1968 Corvette: Service Bulletin: Heat Damage to Engine Wiring Harness at Starter Solenoid

Subject: Heat Damage to Engine Wiring Harness at Starter Solenoid
Model and Year: 1968 Corvette with 396 or 427 Cubic Inch Engine
Source: Chevrolet Dealer Service Technical Bulletin
Bulletin No: 68-T-66
Section: VIy
Date: October 30, 1968

Figure 1

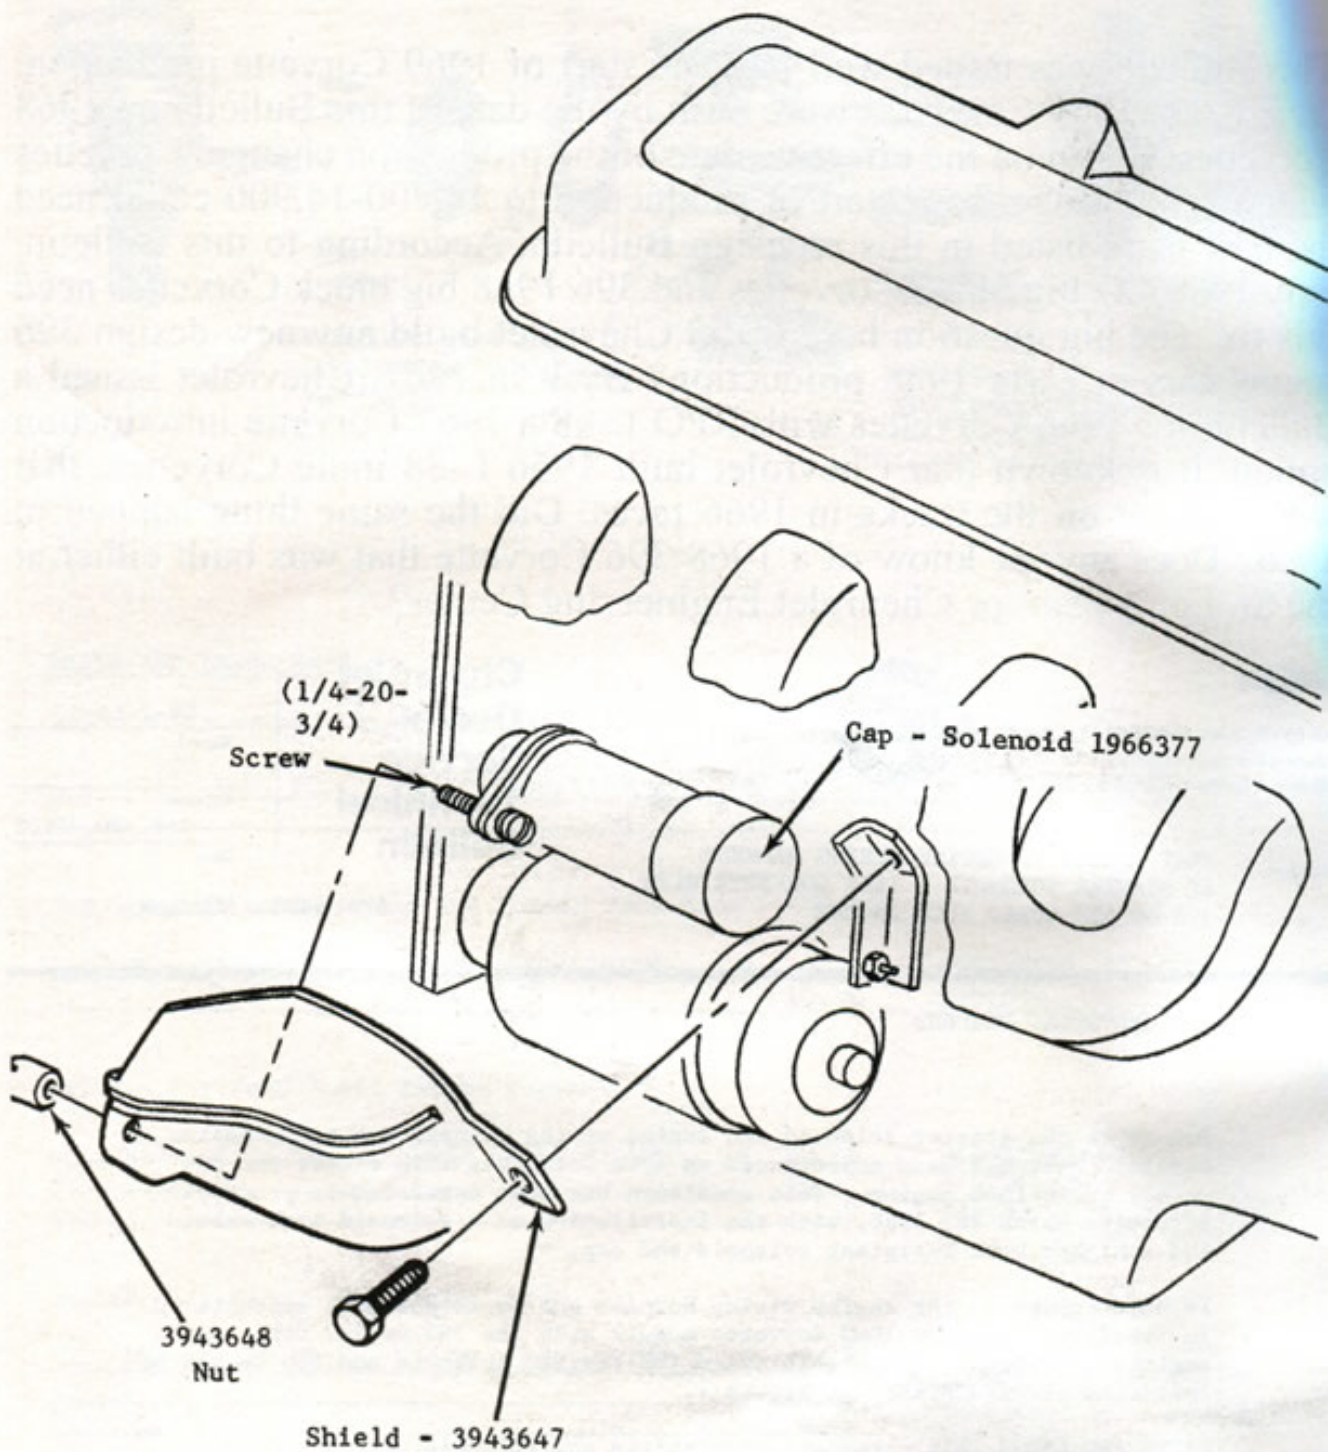
Damage to the starter solenoid and engine wiring harness due to excessive manifold heat has been experienced on 1968 Corvettes with either the 396 or 427 cubic inch engine. This condition has been corrected in production effective March 28, 1968, with the installation of a solenoid heat shield and a higher heat resistant solenoid end cap.

If heat damage to the engine wiring harness and/or solenoid is encountered in the field on early 1968 Corvette models with the 396 or 427 cubic inch engine, the solenoid heat shield and the revised solenoid end cap should be installed as illustrated in figure 1.

QUA.	PART NO.	PART DESCRIPTION
1.	1	3943647	Shield
2.	1	1966377	Solenoid Cap
3.	1	3943648	Special Nut
4.	1	NPN	1/4-20x3/4 Screw
Chevrolet Motor Division General Motors Corporation
